March 28, 2022

Re: Mistis Properties Inc, 176 Virginia Road  
Site Plan Response Memo

This Memorandum responds to the outstanding Site Plan comments set forth in the Kellard Sessions Consulting, P.C. Memorandum, dated May 7, 2021. Kellard's comments are provided attached, Our responses are noted below in bold, blue and italics.  
Included here within:

**DRAINAGE & GRADING PLAN**  
1" = 20' - 0"

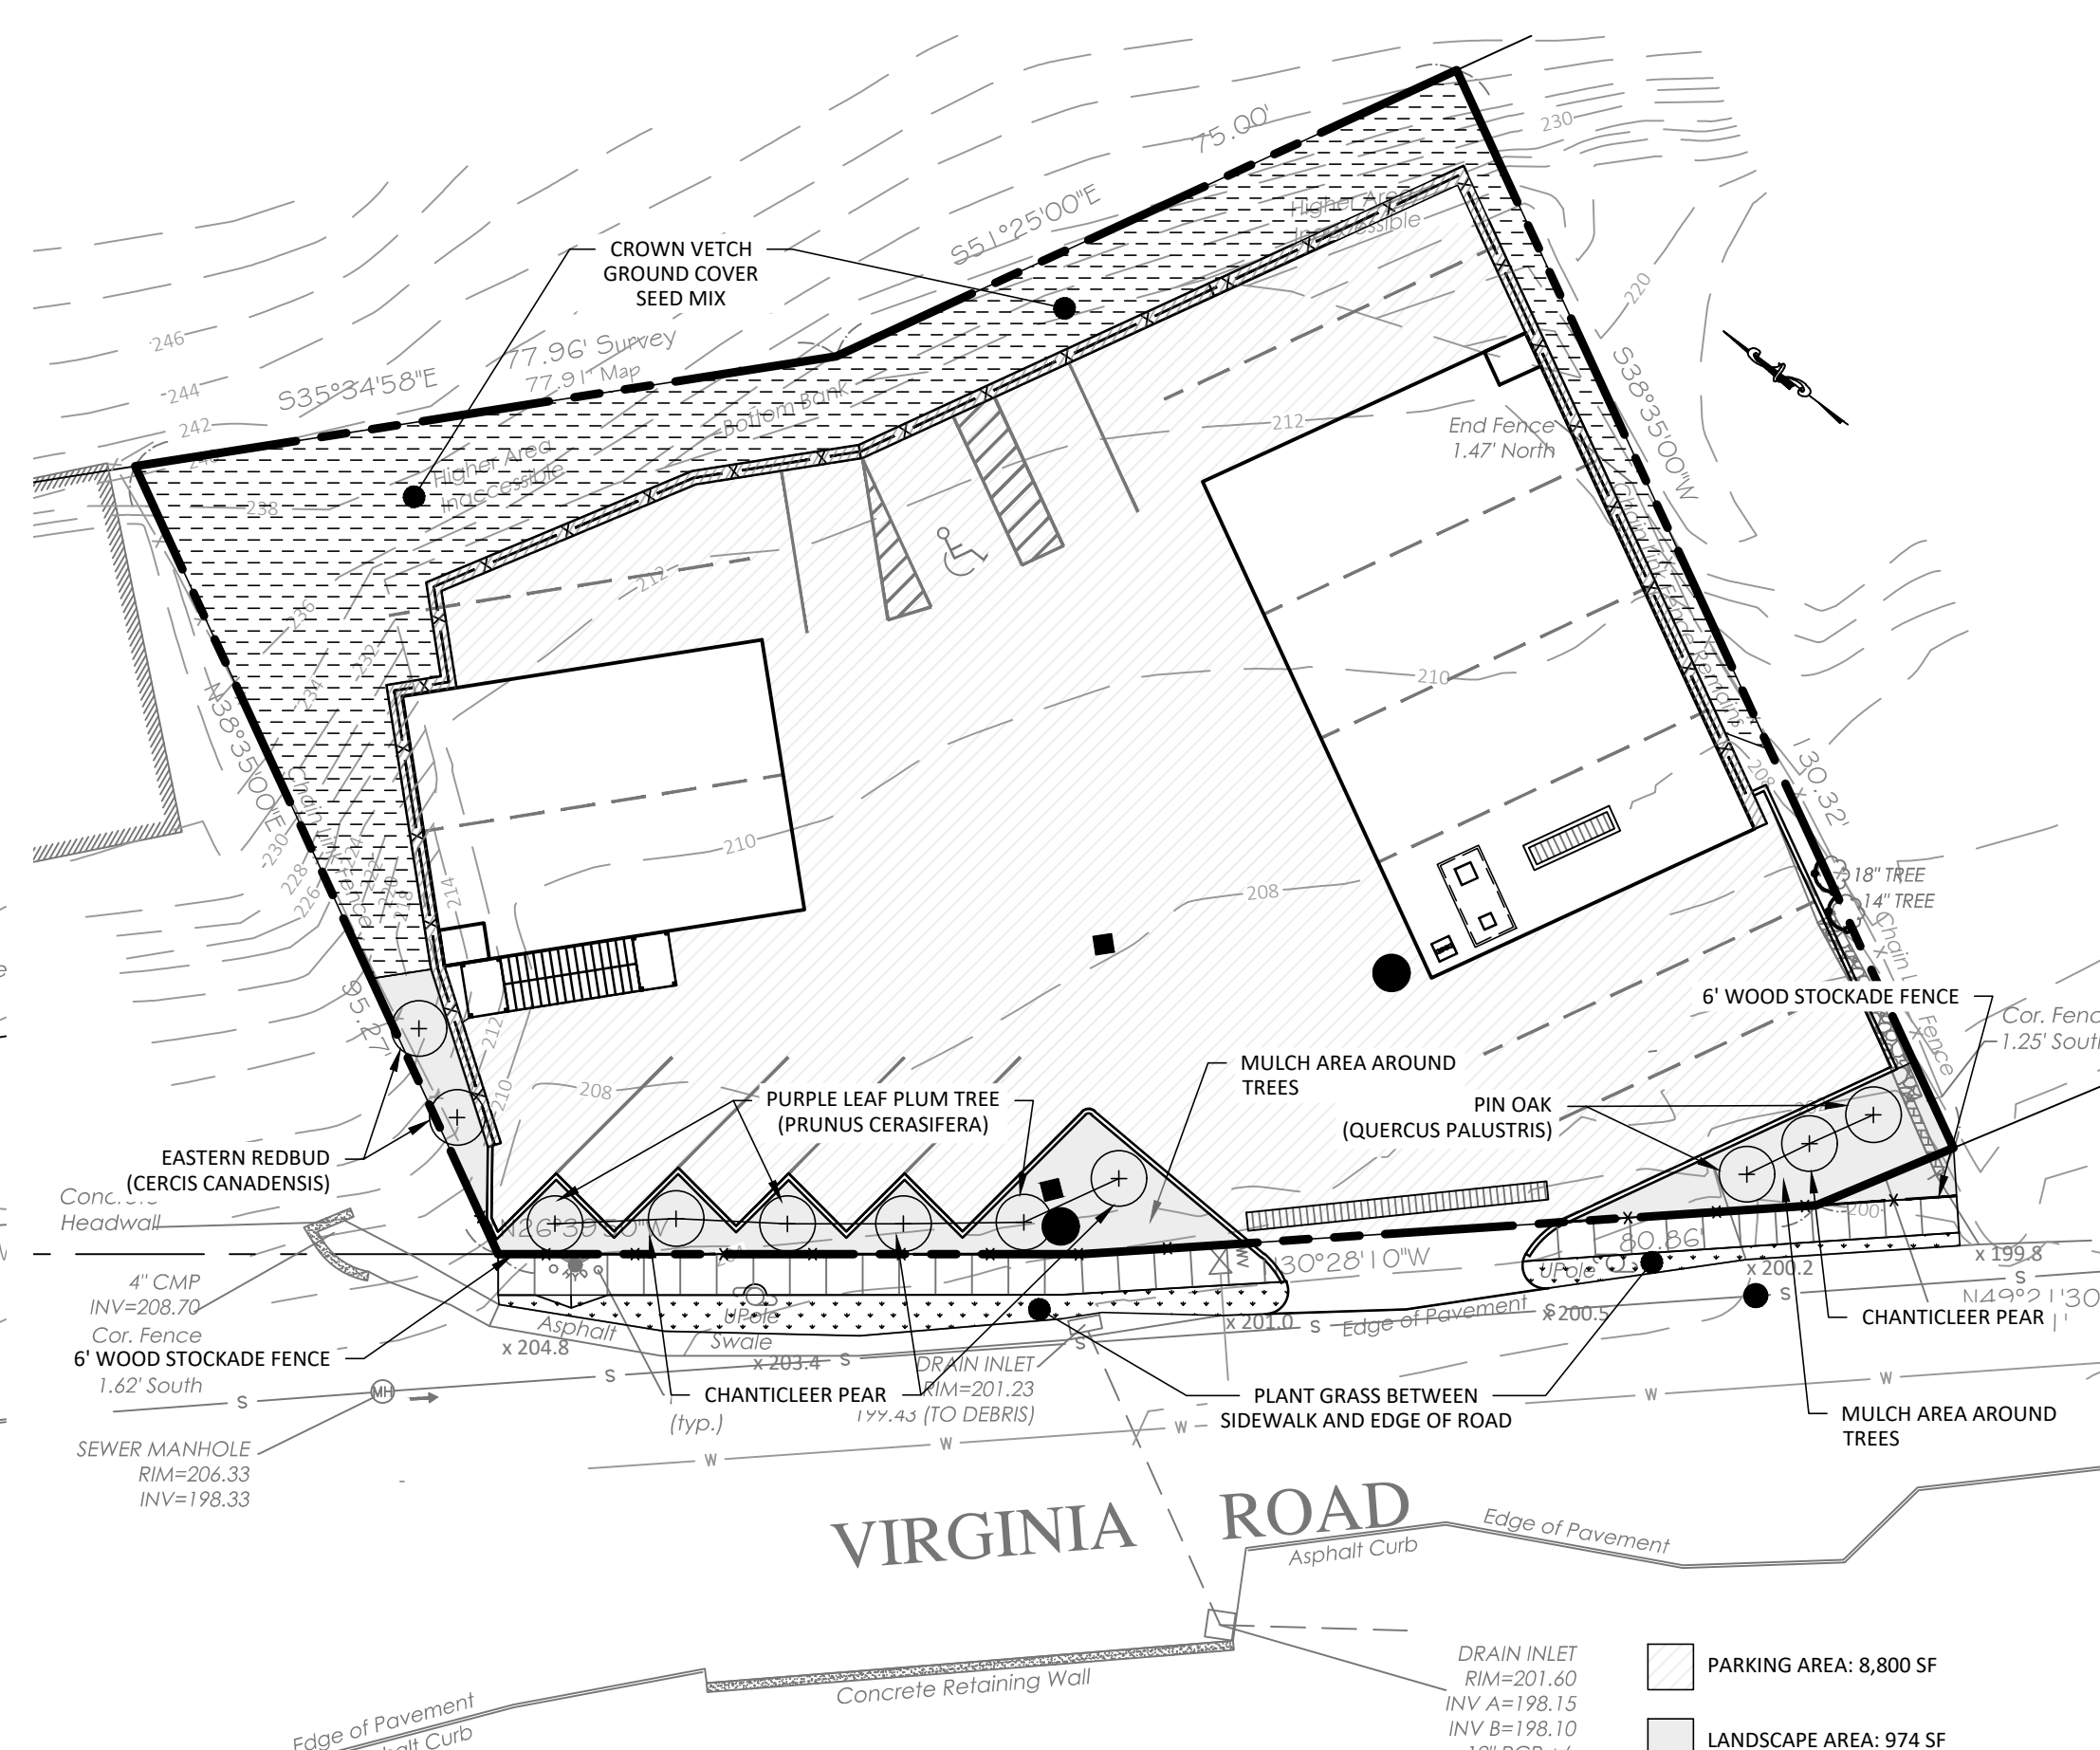
6. The hydrologic model demonstrates that the proposed stormwater management system will effectively mitigate the increased stormwater runoff generated by the project. However, it is suggested that the plan be revised to also connect the roof leaders of the proposed 2-bay warehouse (north building) and proposed Drain Inlet, DI-1. Doing so would allow for the connection of Drain Inlet, DI-1, to the proposed Stormtrap System, rather than the current proposed 6"x6" PVC TEE connection, (which would not be acceptable) and eliminate the multiple connections at Drain Inlet, DI-2. This would also provide mitigation and treatment for all impervious surfaces. The outlet structure shall be labeled on plan Sheet S-2.

7. The proposed outlet structure need clarification. The Detail on Sheet S-5 indicates a connection to the hydrodynamic separator: however, there is no indication of this on plan Sheet S-2. The detail also indicates outlet pipes of twelve (12) inch and four (4) inch diameter, while the plan illustrates a six (6) inch outlet pipe to Drain Inlet, DI-2. Please clarify. It appears that an additional structure will be required for the pipe transition or an alternate outlet structure design. The six (6) inch pipe connection should also be included in the hydrologic model. It currently appears to be undersized.

*Plans were updated as per comment. (All roof and driveway area to DI-1 now directed to Stormtrap system. Outlet Structure labeled on S-2.)*

*Plans were updated as per comment. (See plan on Sheet S-2 and Detail on Sheet S-5)*
